CITY OF PORTLAND

Your application for a building permit to erect a 20' x 32' wooden storage and work shed at 94 - B - 36 Fern Avenue, Long Island is being issued with the following requirements:

To erect 20' x 32' wooden storage & work shed as per plans, 1 sheet of plans.

JAMES KUNTZ
FERN AVE LONG ISLAND MAINE.
94-B-36

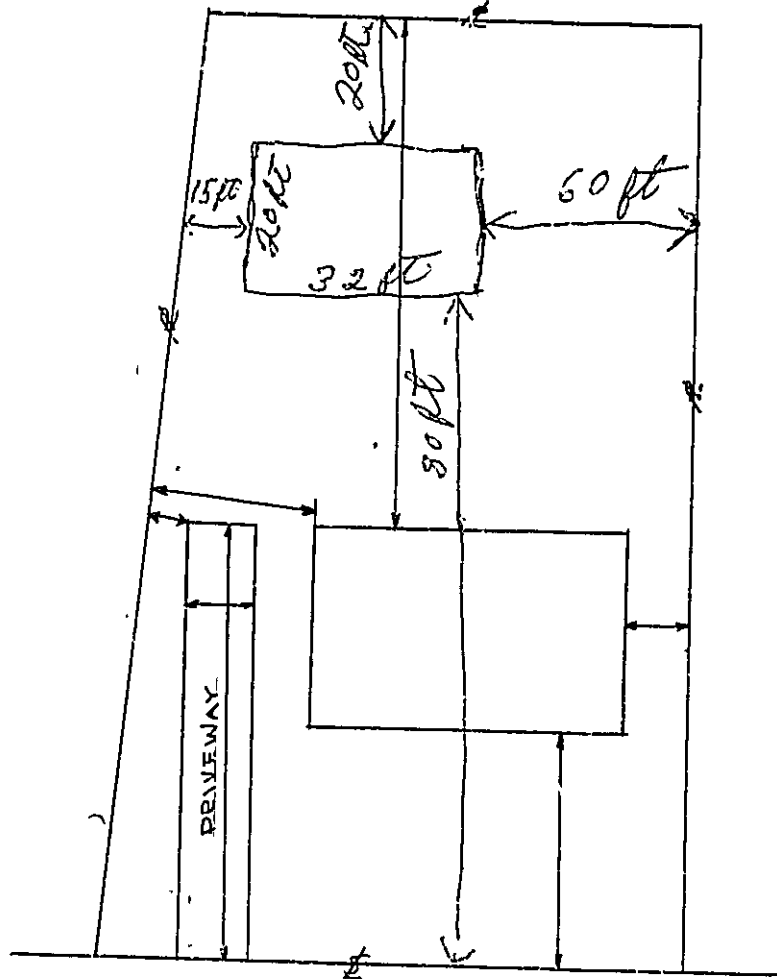
1. The 4" x 10" on your plan is the carrying beam in center of 20' span with 2" x 6" floor joist spanning 10' spaced 16" o.c.;
2. Piers and footing spaced maximum of 8';
3. Rafters will be 2" x 6" 16 o.c.
